Re: U.S. Patent Application Serial No.: 09/650,969  
Filed: August 29, 2000  
Confirmation No.: 8650  
Notice of Allowance Mailed: March 29, 2004  
Title: NEAR FIELD OPTICAL APPARATUS  
Inventor: Robert L. THORNTON et al.  
Our File No.: ST 2622.01 US

**PETITION TO WITHDRAW HOLDING OF ABANDONMENT  
UNDER 37 C.F.R. § 1.181 (a)**

Fig. 27 (PRIOR ART)

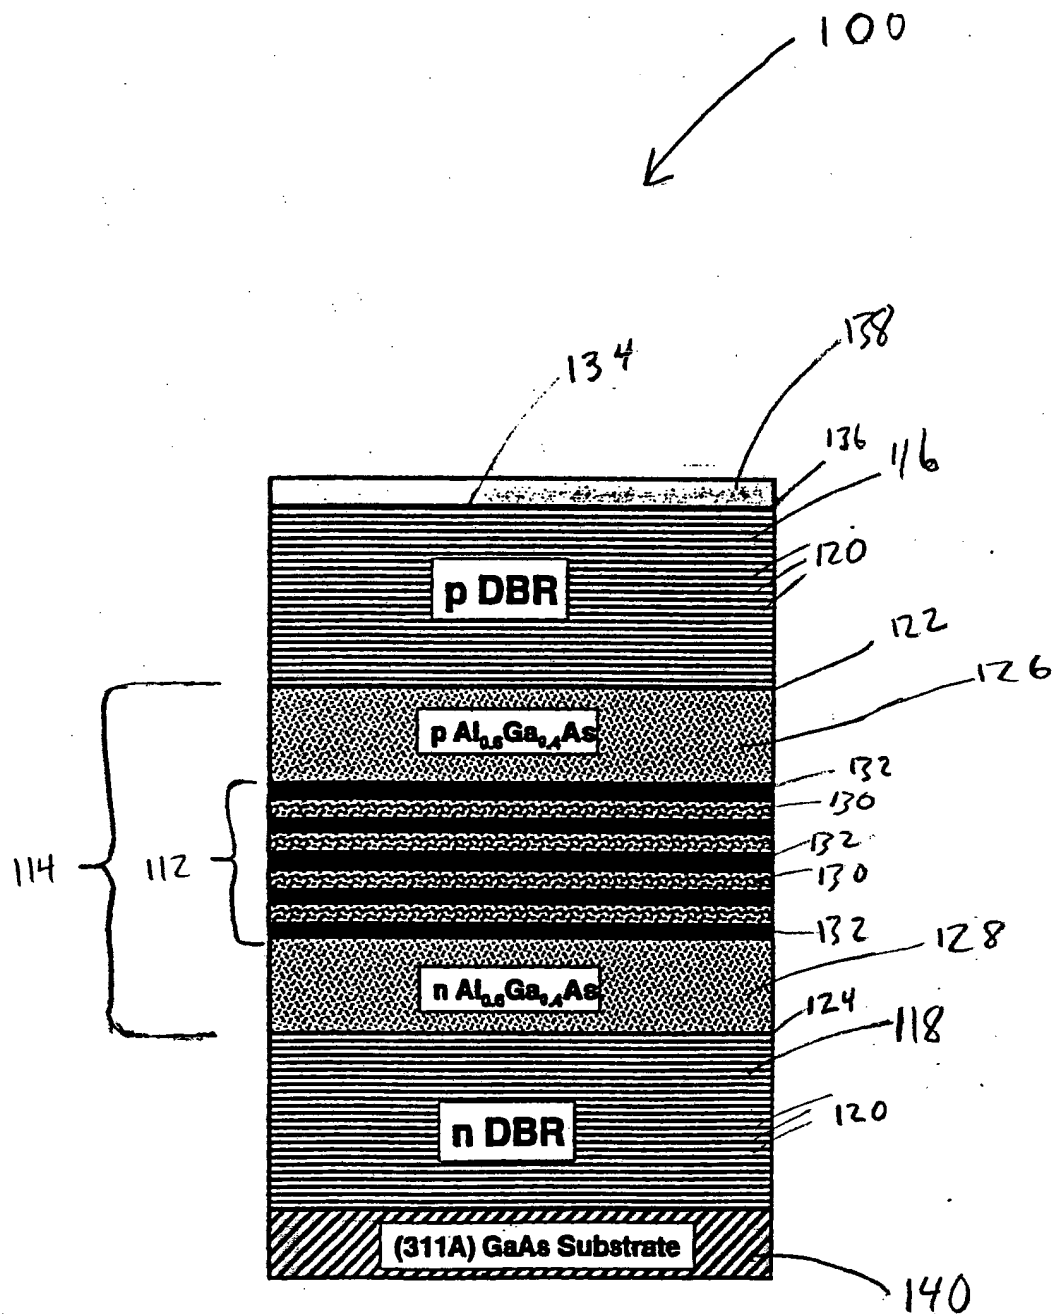
- a) The Office action with the mailing date of 04/24/2002 stated that "The drawing(s) filed on 29 August 2000 is objected to by the Examiner" (a copy is attached hereto as Exhibit B). On page 2 of said Office action, the Examiner objected to the drawing because Fig. 29 does not have reference number 118.

- b) A Response, which included the corrected drawing, was filed on October 24, 2002. As stated in the Response, it is believed that the Office action intended to imply that Fig. 27 was in error not Fig. 29 (a copy of the Response and the filing receipt are attached hereto as Exhibit C).

The drawings are objected to as failing to comply with 37 CFR 1.84(p)(5) because they do not include the following reference sign(s) mentioned in the description: Figure 29 does not have reference number 118. A proposed drawing correction or corrected drawings are required in reply to the Office action to avoid abandonment of the application. The objection to the drawings will not be held in abeyance.

9. In the alternative, it is respectfully submitted the corrected drawing(s) herein as attachment 1.

Submitted herewith for the Examiner's approval are proposed amendments to FIG. 27. The proposed amendments to the figure are indicated thereon in red ink. It is believed that the office action intended to imply that FIG. 27 was in error not FIG. 29.

The FIG. 27 has been amended to correct the numeral “18” and provide the proper reference numeral “118.” Entry of the amendments is respectfully requested.
